**COUNTY OF SAN MATEO  
PLANNING AND BUILDING DEPARTMENT**

**SUBJECT:** STAFF REPORT ADDENDUM: Consideration of a Coastal Development Permit, Use Permit, Variance, and Design Review Permit, pursuant to Sections 6328.4, 6500, 6530, and 6565.3, respectively, of the San Mateo County Zoning Regulations, and a Grading Permit, pursuant to Section 9283 of the County Ordinance Code, for the construction of a new 10,178 sq. ft. fire station to replace the existing Fire Station 44, on a 21,695 sq. ft. property located at 501 Stetson Street in the unincorporated Moss Beach area of San Mateo County. A Variance is requested for a reduction in the front setback and an exceedance of the maximum floor area of the zoning district. The project is appealable to the California Coastal Commission. In conjunction with the requested permits, it is recommended that the Planning Commission determine that the project is categorically exempt from California Environmental Quality Act (CEQA) pursuant to CEQA Guidelines Section 15302.

County File Number: PLN 2023-00311 (Coastside Fire Protection District/Duncklee)

**PROPOSED SITE PLAN & TREE PLAN**

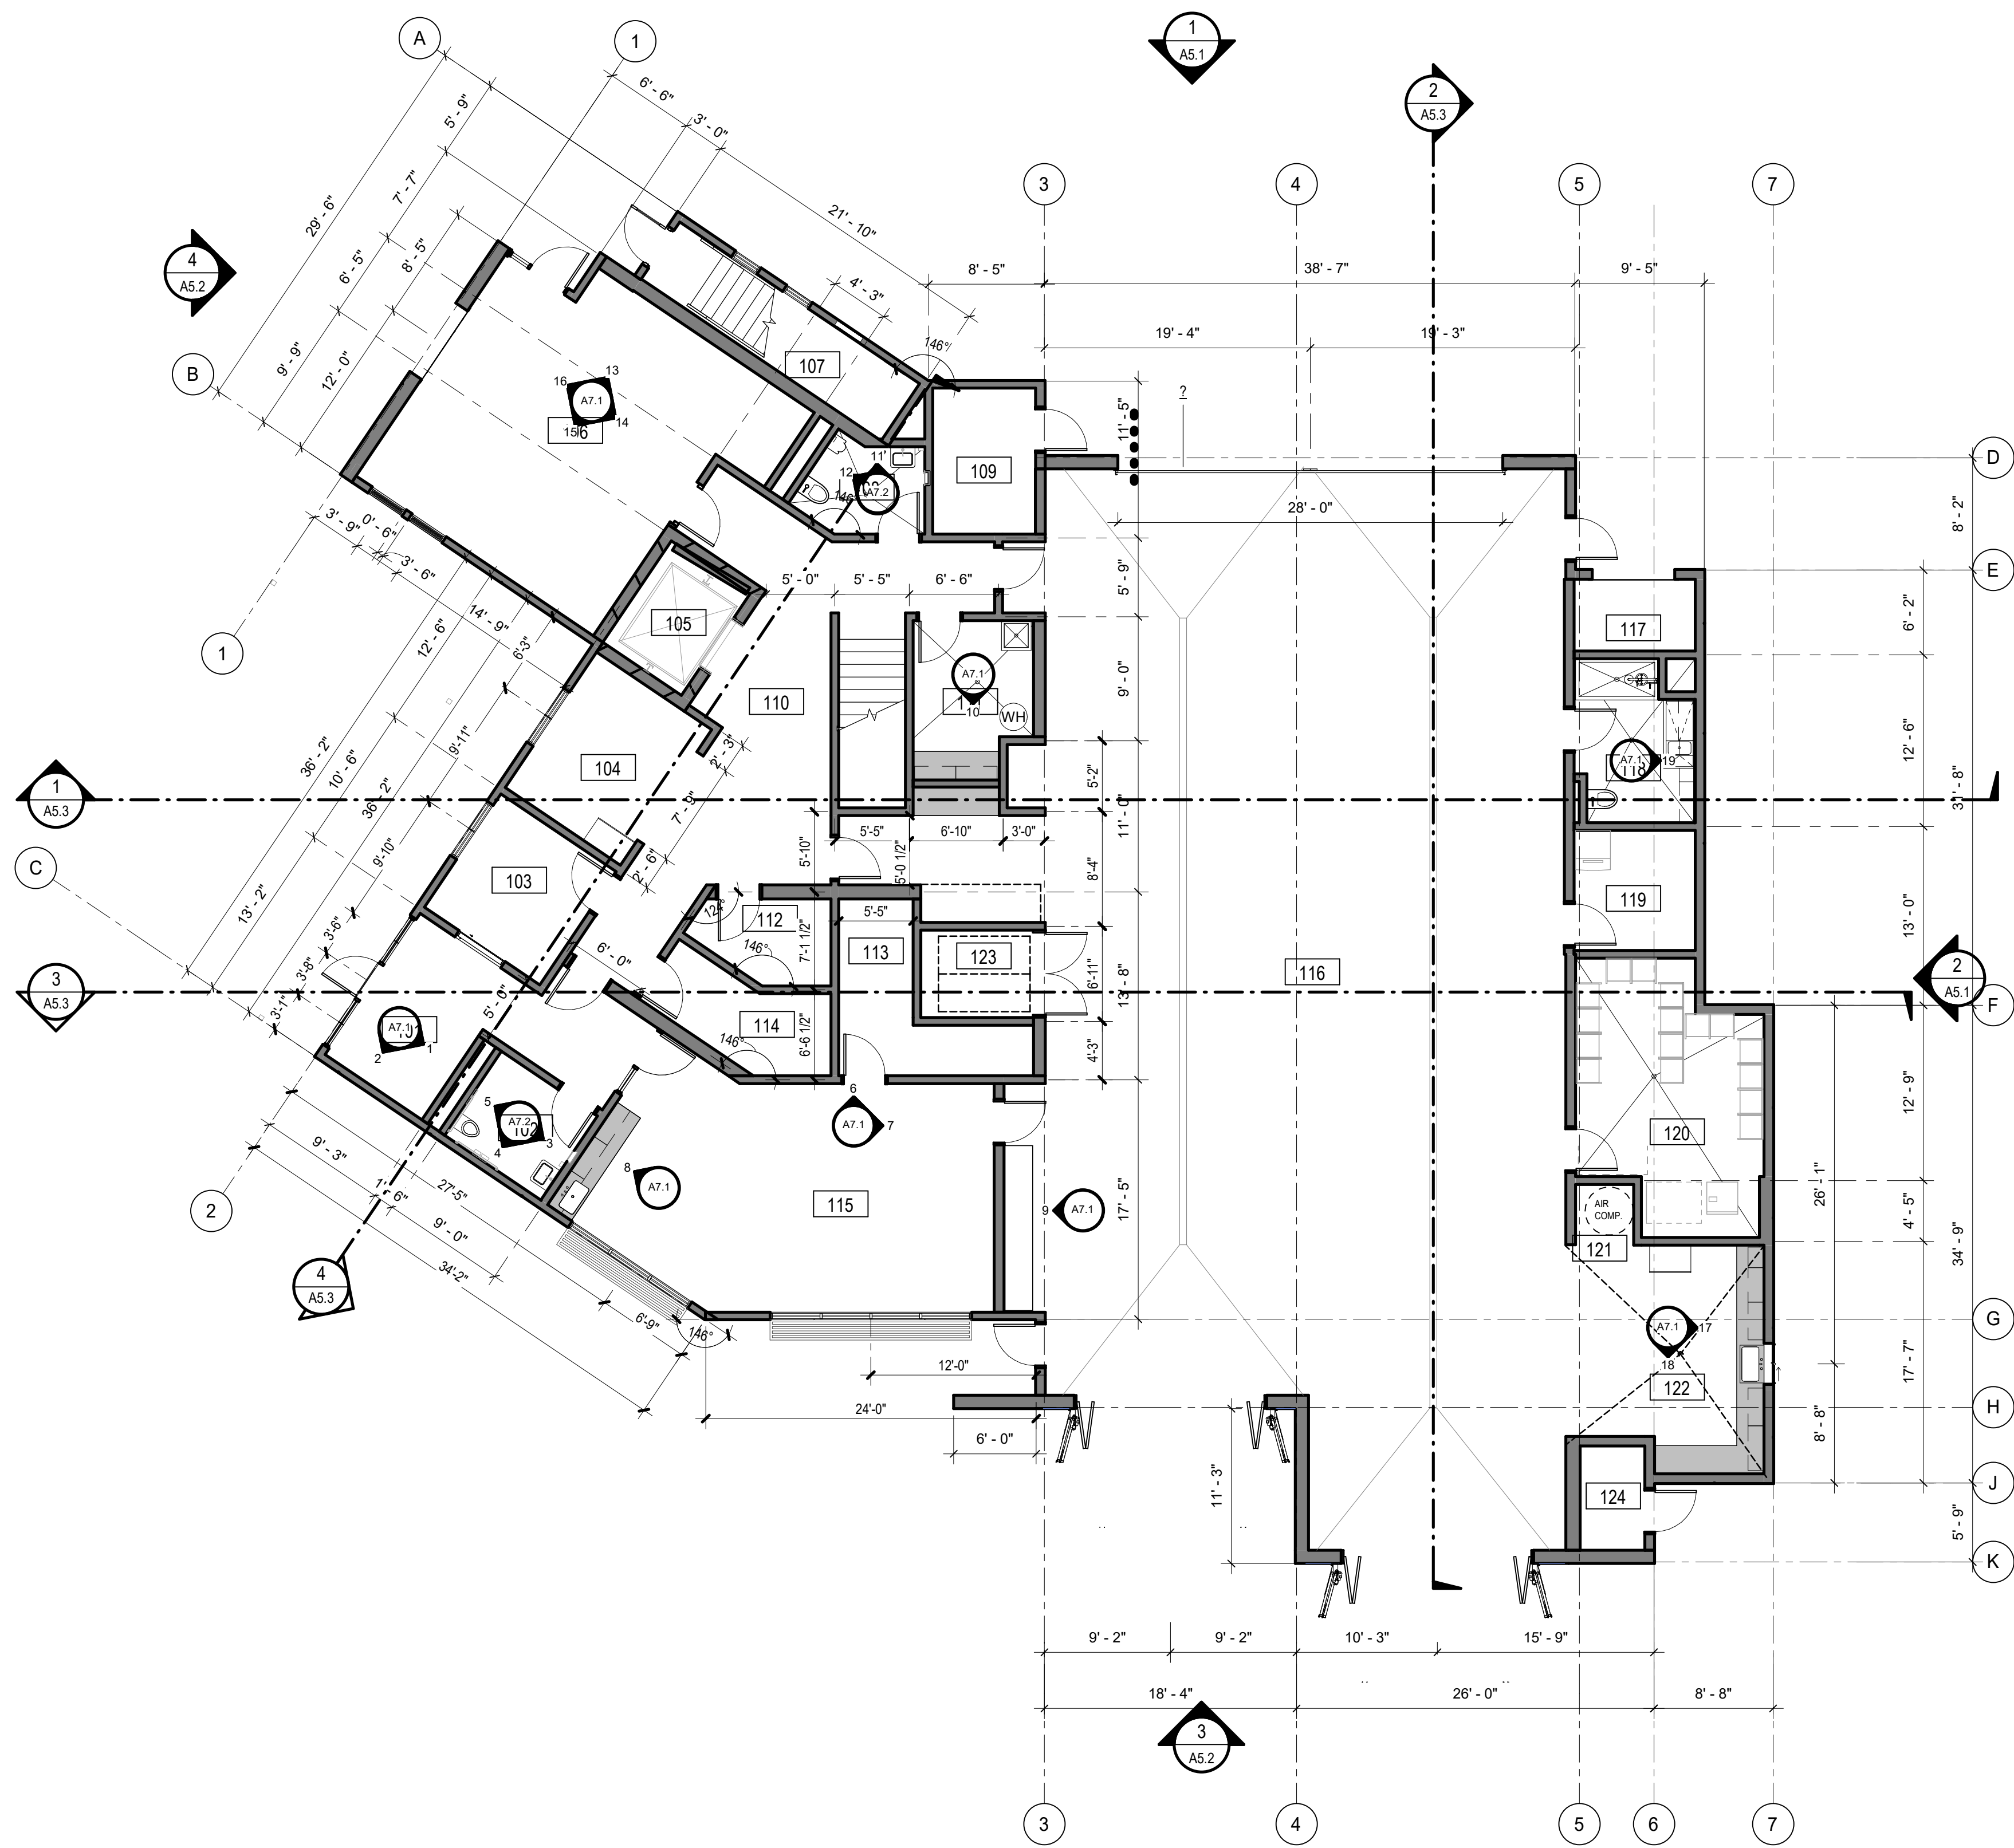
COMMENT: Suggested relocation of the apparatus bays to the north side to reduce impacts on denser south side.

RESPONSE: This comment would be impactful to the overall design of the project, especially the return/response drive design.

**PROPOSED EXTERIOR ELEVATIONS**

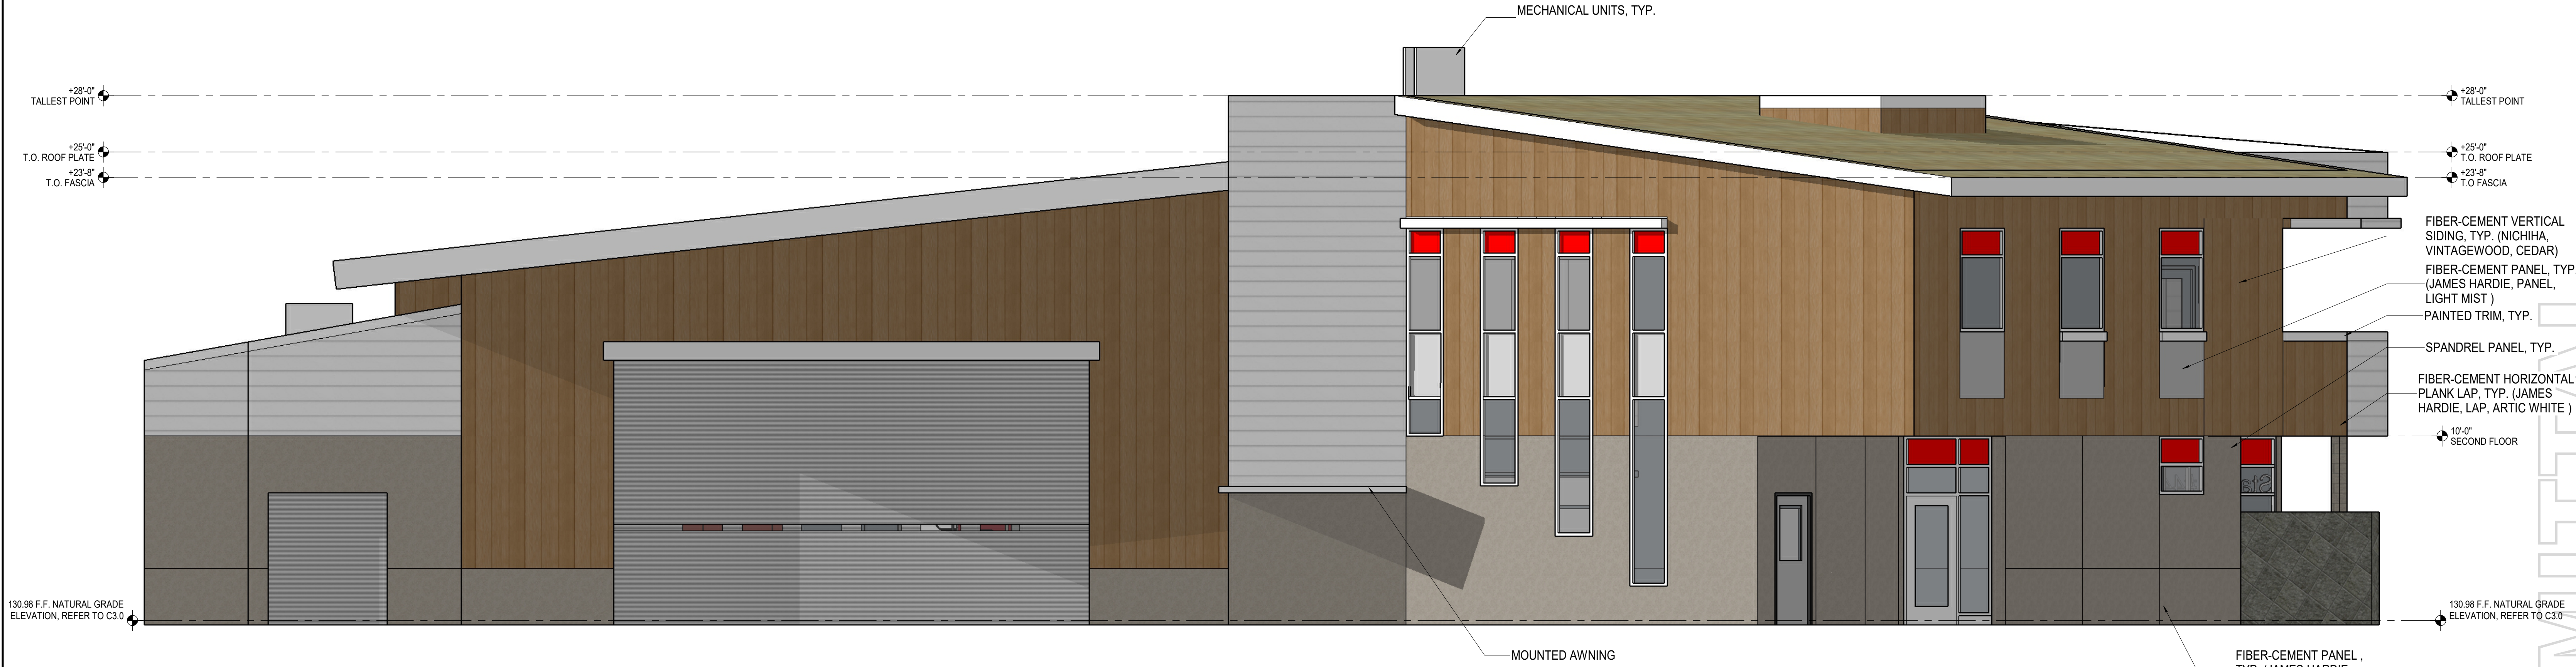
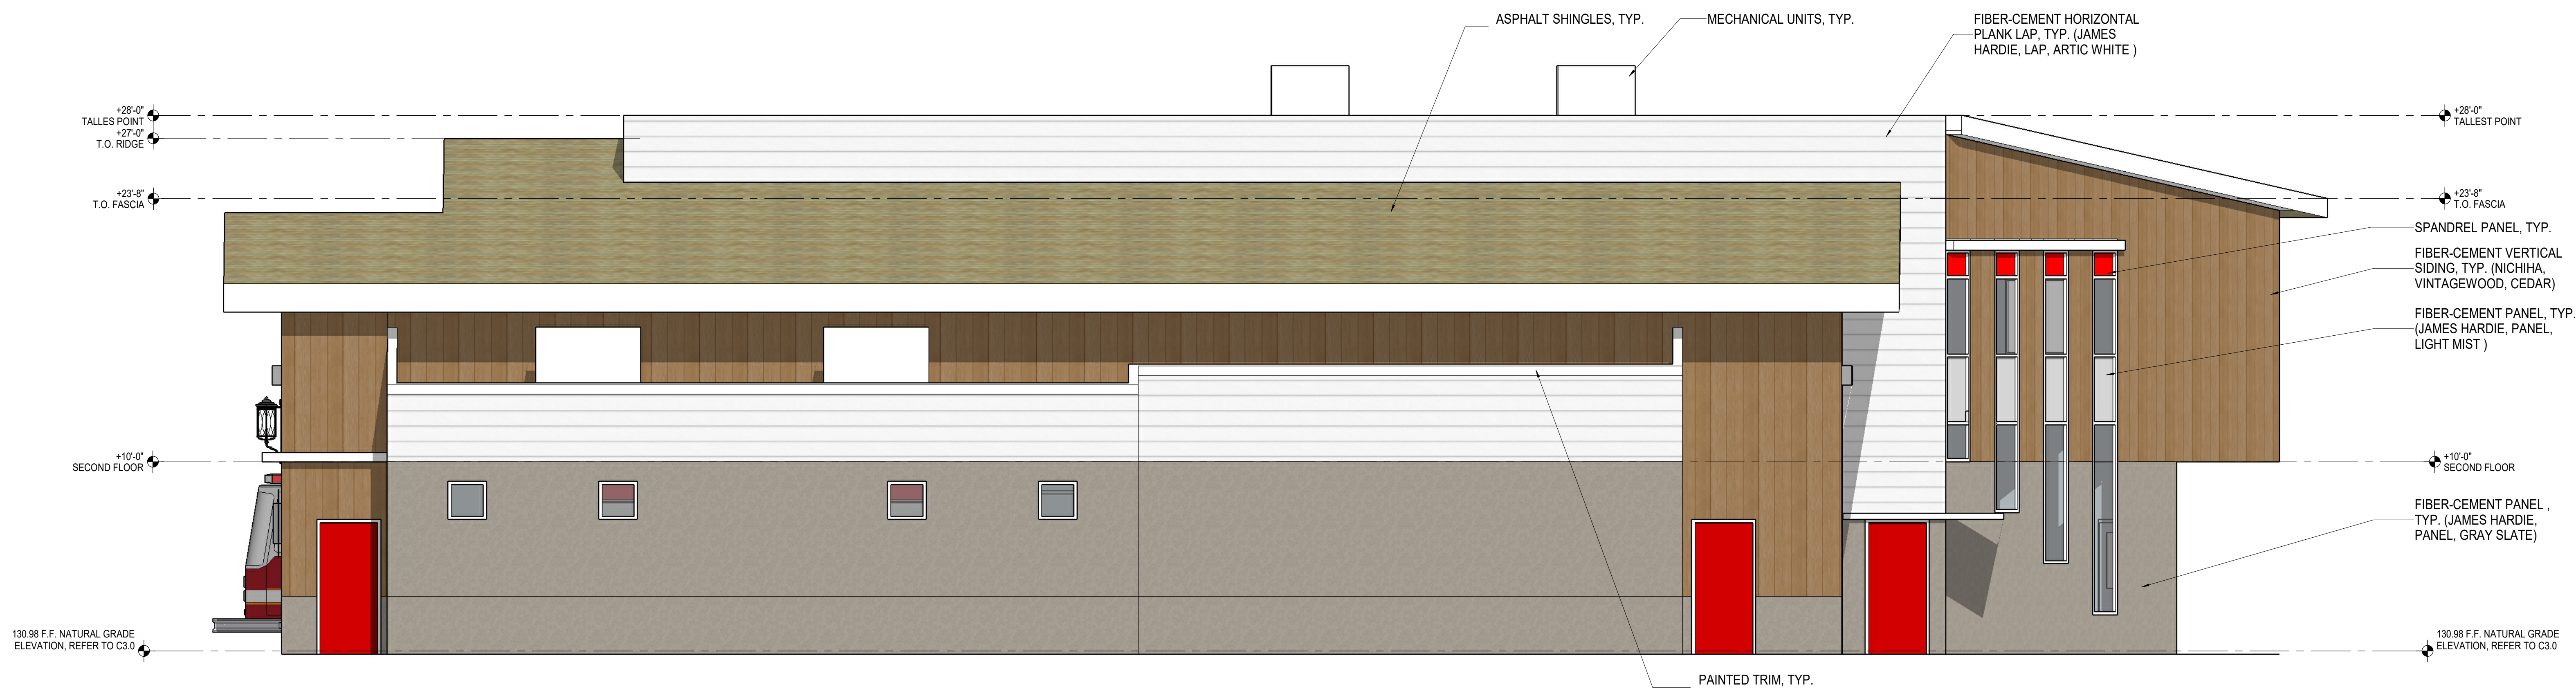
COMMENT: Suggested changing the upper floor white sidings/paint to earth-tone, non-reflective colors/materials.

RESPONSE: See updated exhibit with updated exterior materials. The exterior colors have been revised to eliminate the white siding and feature more of an earth tone scheme.
